MEMORANDUM

SUBJECT: ZC Case 05-28K: Setdown Report for a Modification to an Approved First-Stage PUD, filed by CI GD Parkside 7 LLC.

Building Height

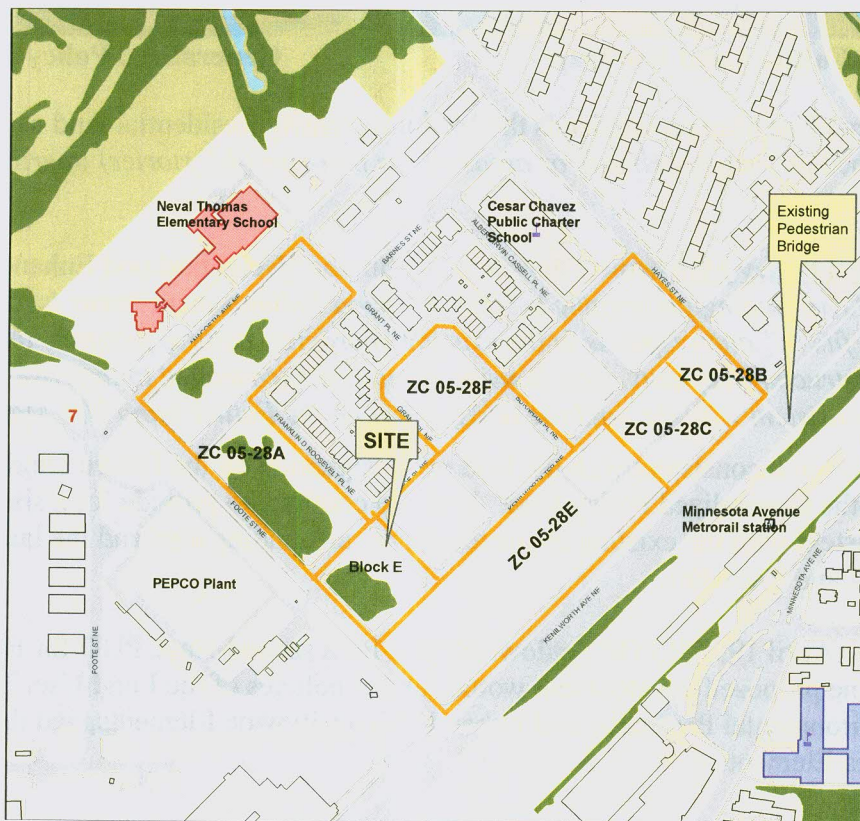
The application proposes to modify the building height. The building would continue to step-down from the high-rises proposed to be built across Kenilworth Terrace to the townhouses approved across Parkside Place, but less dramatically. Height of the building would max out at 81 feet, four inches, instead of 90 feet, and the minimum height would increase from 54 to 60 feet.

The proposed modifications would allow for the majority of the building to six stories, with only the ends facing Parkside Place at a lower height. The maximum height would be for the lofts generally on the Kenilworth Terrace side of the building, and not for entire floors. This would result in a

building that is either five or six stories in height, is stick-built as opposed to concrete construction, and has three stairwells for fire egress, instead of five.
